Control No. PCN-23143

PRODUCT/PROCESS CHANGE NOTIFICATION

An existing qualified leadframe supplier, Hua Yang, will be added as an alternative leadframe supplier for 140x200 mil leadframe to be used for the LinkSwitch SMD-8B products listed in below.

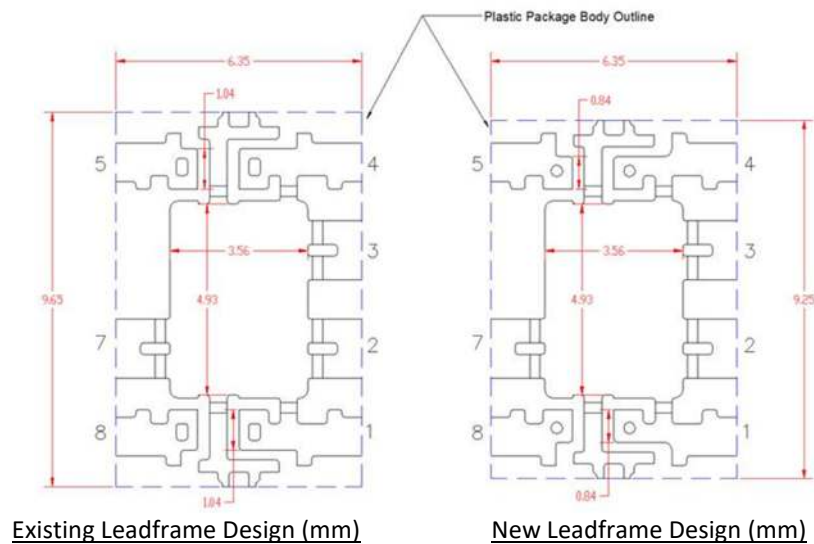
This leadframe internal design configuration will remain the same as shown in the figure below, but there will be some small dimensional changes to inner lead features that will not affect fit, functionality or performance of the product. The plastic body length will also change as shown in the figure, but the new dimension is still within our datasheet package drawing tolerances.
